Memorandum to the City of Markham Committee of Adjustment

September 10, 2021

File: B/003/21
Address: 45 Sciberras Road – Markham, ON
Applicant: William Xue
Agent: Prohome Consulting Inc. (Shahramb (Sean) Khatibzadeh)
Hearing Date: September 22, 2021

APPENDIX "C"
SITE PLAN [PART 1 (45B) AND PART 2 (45A)]

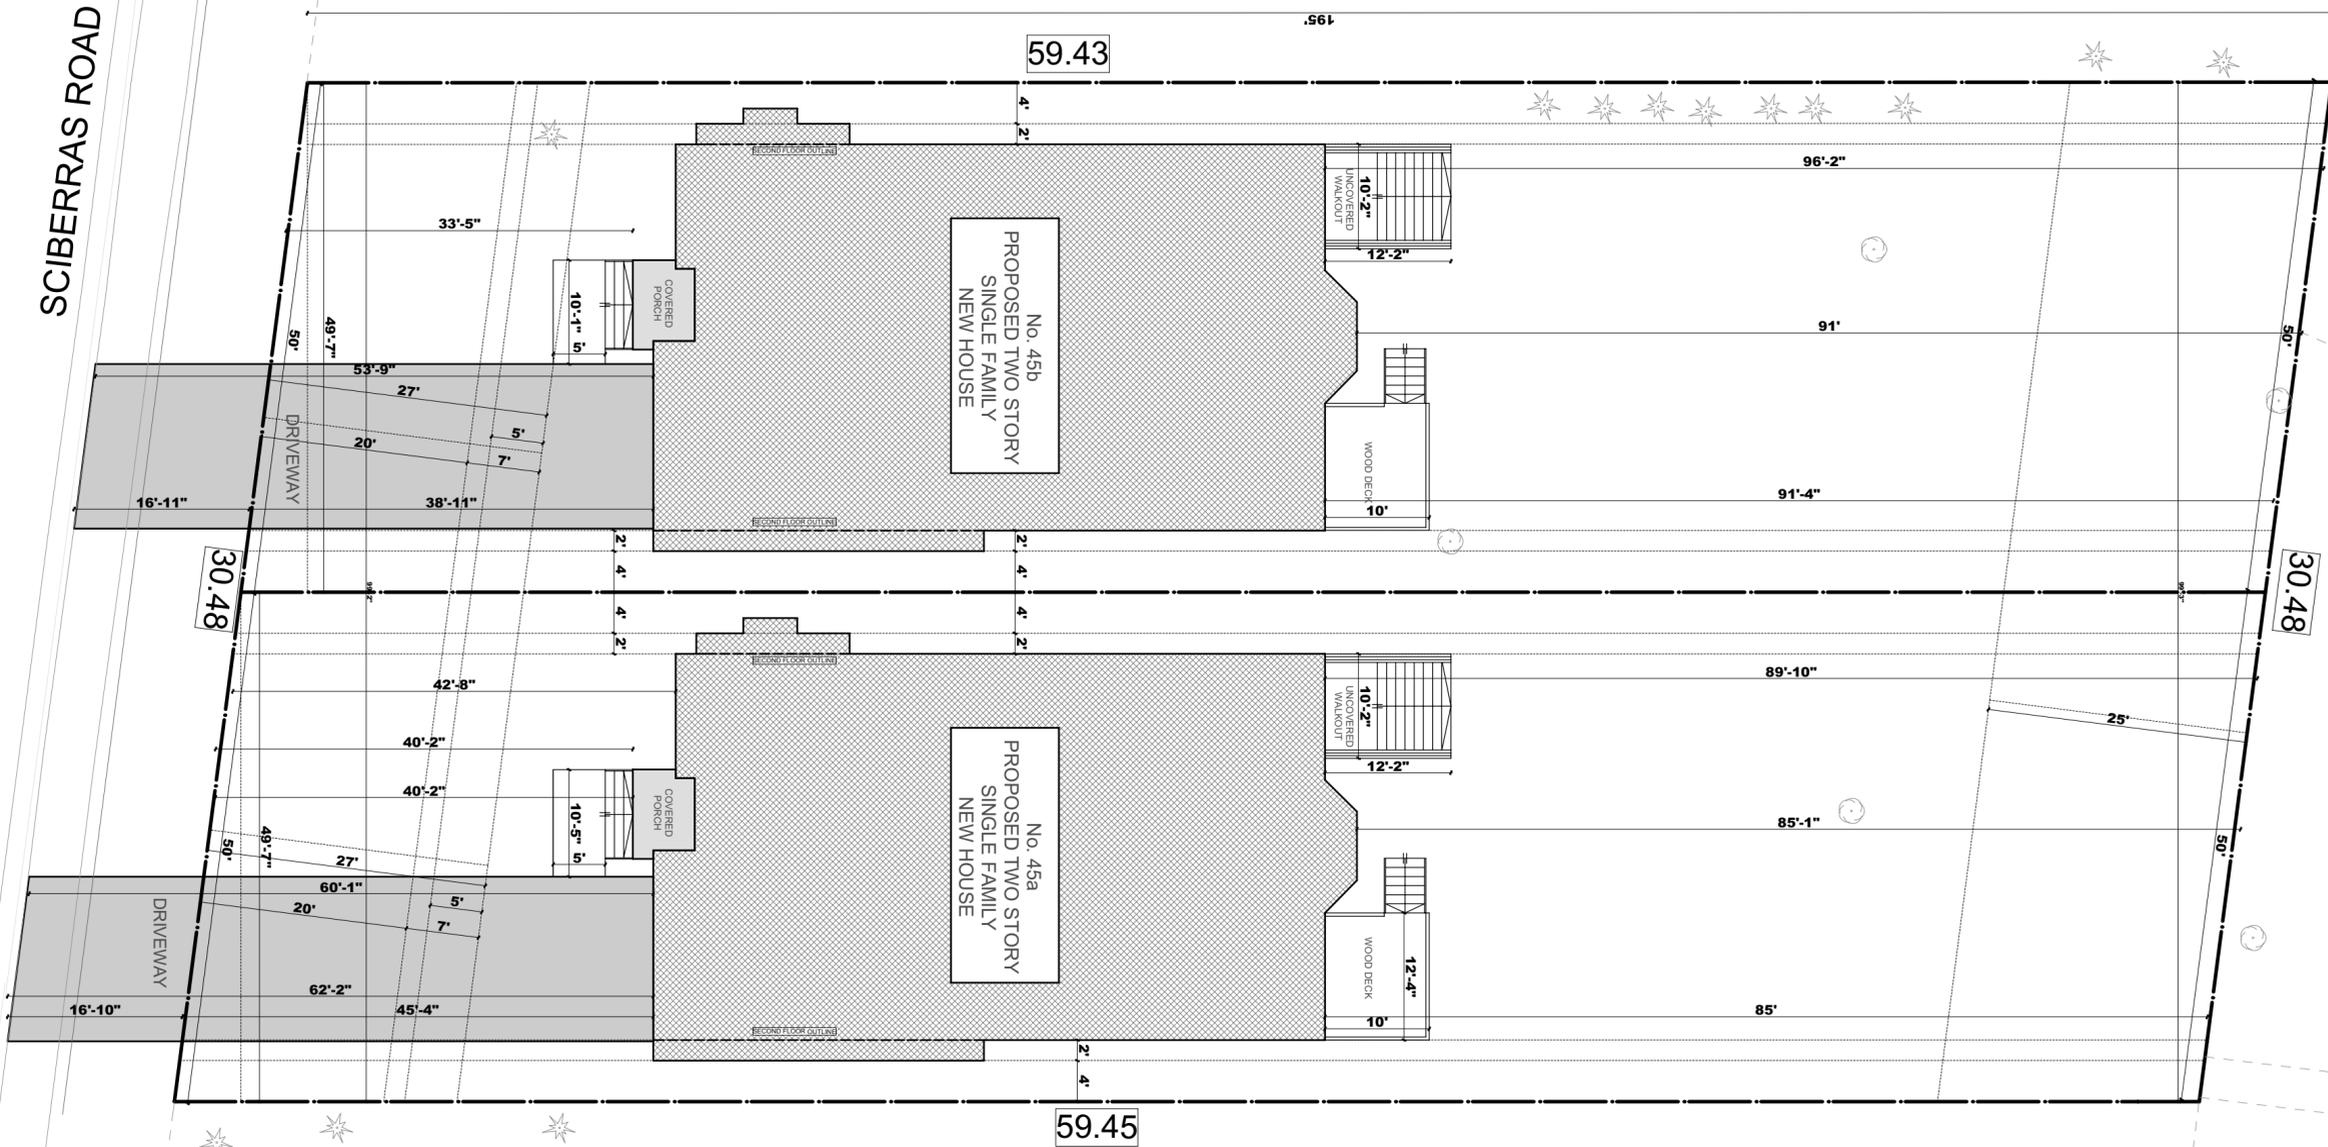
The applicant proposes to sever the existing residential lot to facilitate the creation of one new additional residential lot. Both lots would have equal lot frontages of 15.24 m (50.0 ft), and lot areas of 898.40 m² (9,671.05 ft²). The applicant is also proposing to demolish the existing one-storey detached dwelling to construct two new two-storey single detached dwellings, one on the retained lot (Part 1, the north parcel), and the other on the severed lot (Part 2, the south parcel) (see Appendix "C").
